SDP - Comment Response Letter

Citizen on Constitution  
El Paso County, Colorado

Prepared: October 26th, 2022

**ONSITE CD'S – PCD ENGINEERING  
COMMENT RESPONSE**

THE CITIZEN ON CONSTITUTION  
 EL PASO COUNTY, COLORADO  
 GRADING EROSION CONTROL AND  
 CONSTRUCTION DOCUMENTS  
 PROPOSED DRAINAGE MAP

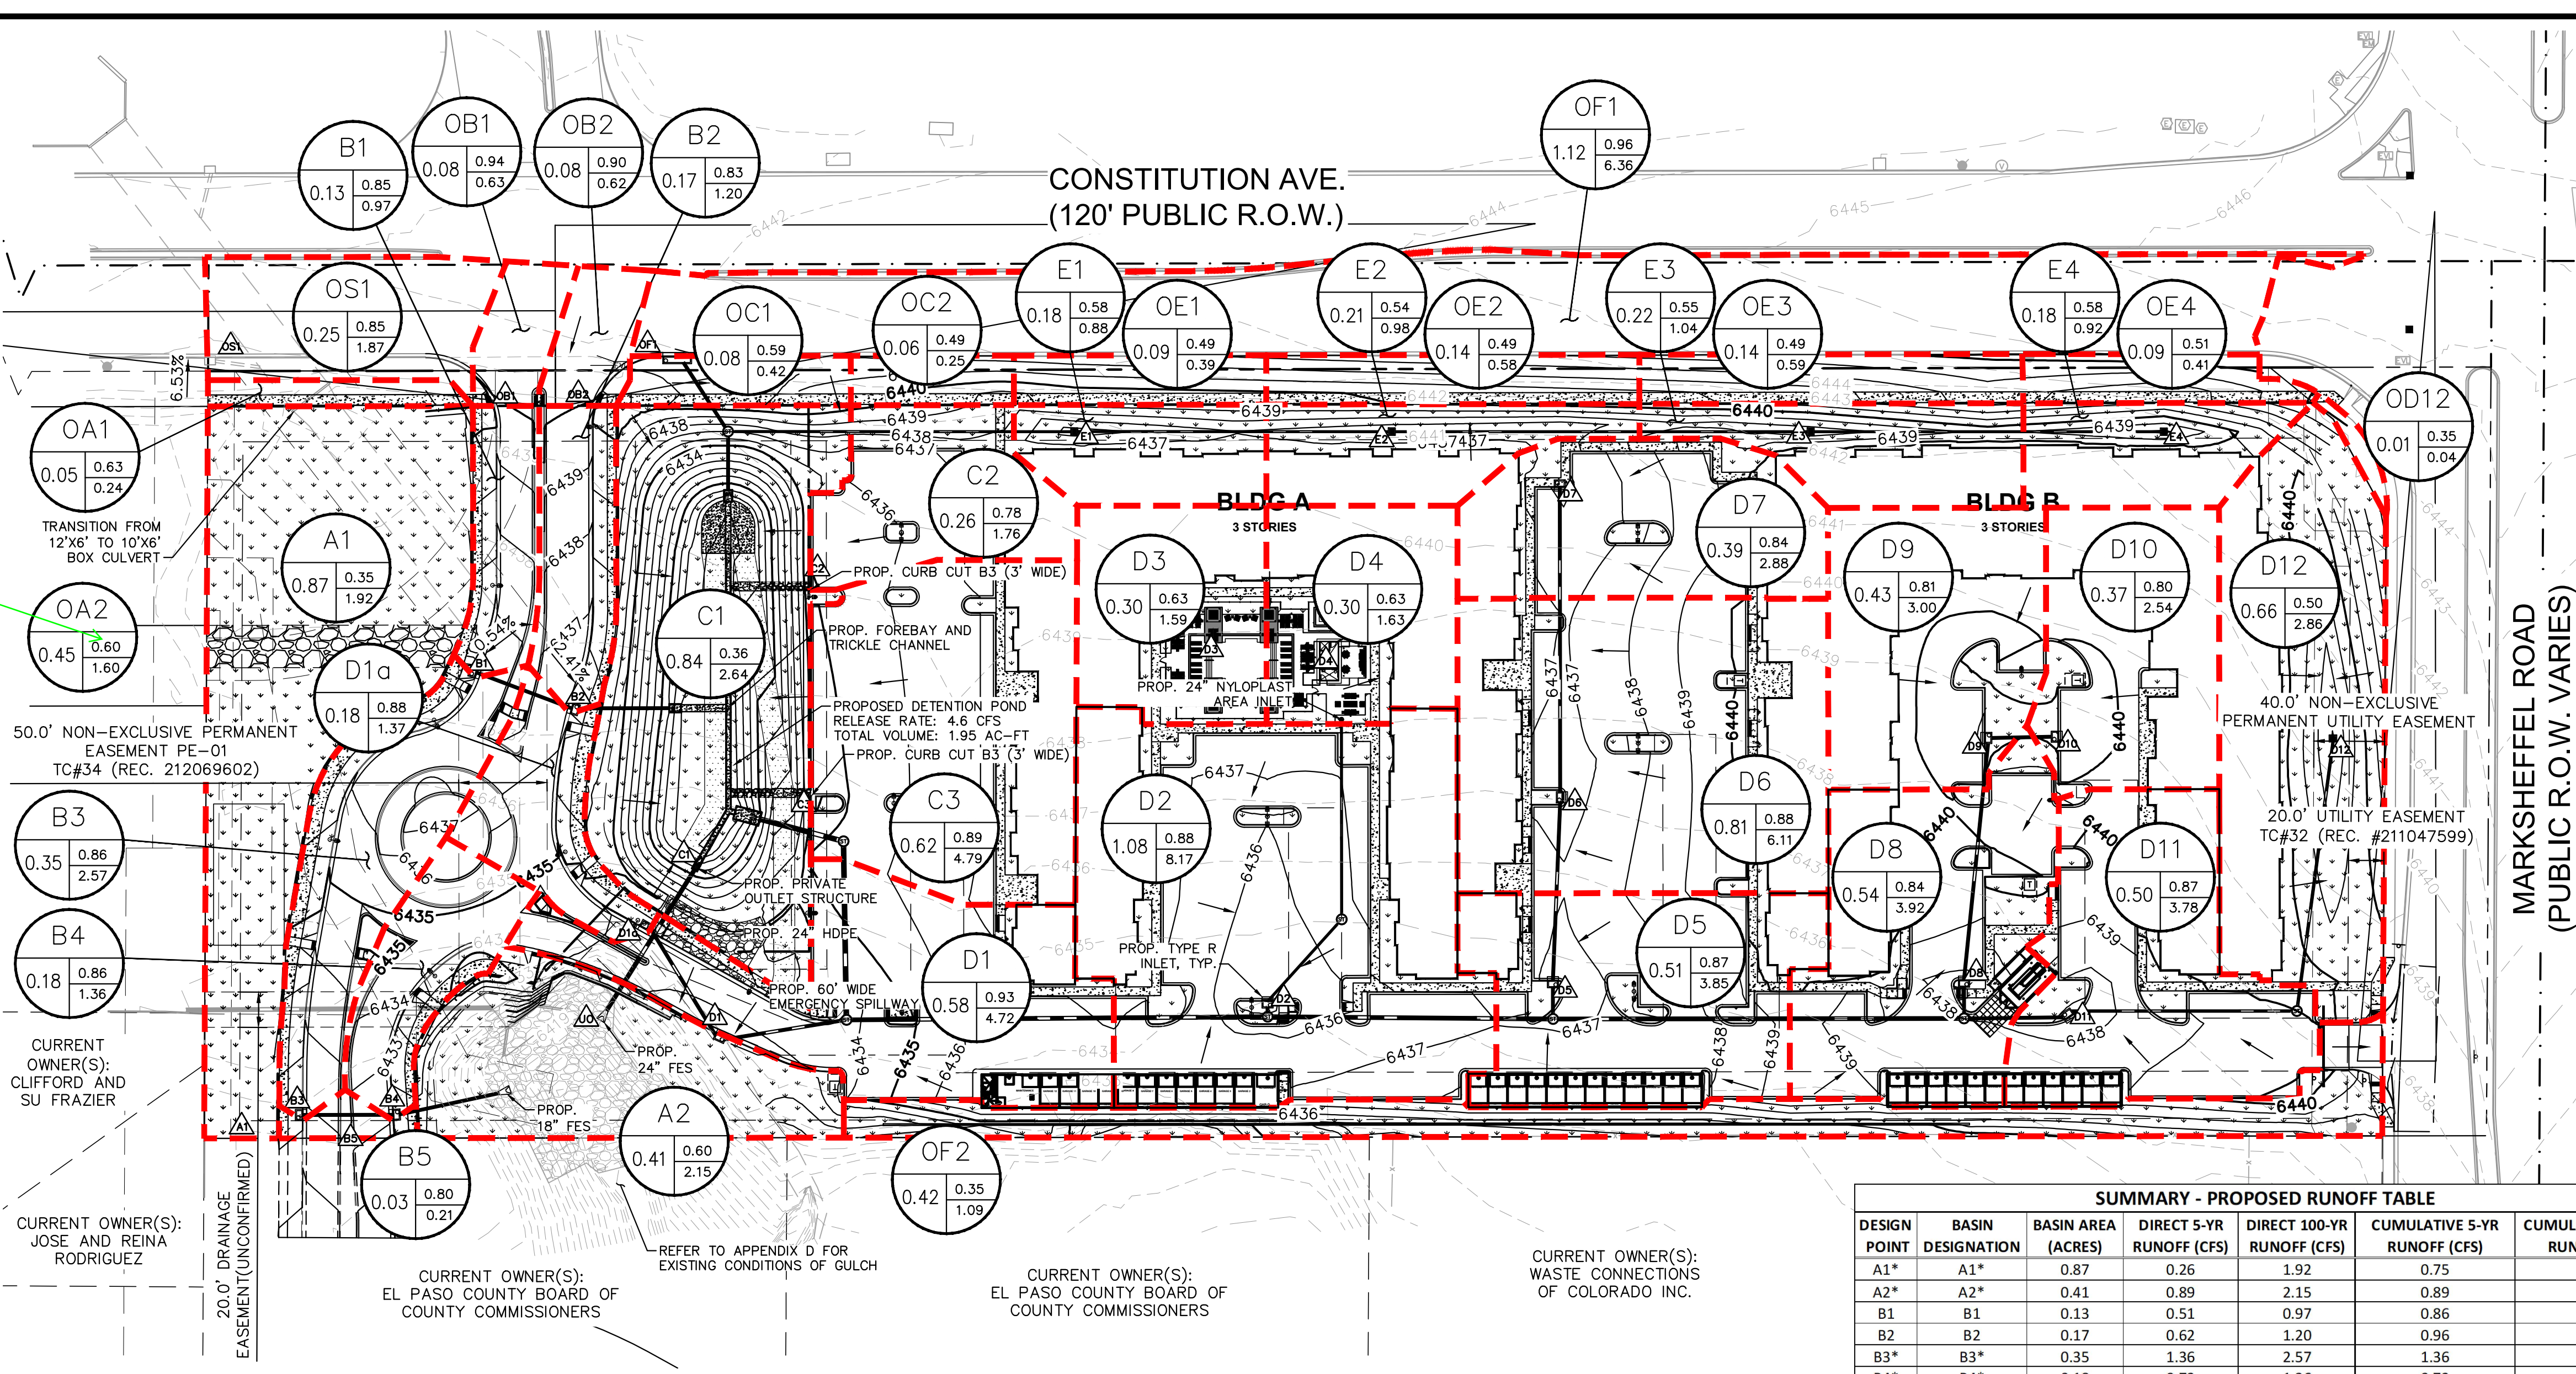
Does not match what is shown on Drainage Map

KH Response: Per response in report, the values in the DP summary table have been used as they are more conservative than the values in the basin summary table
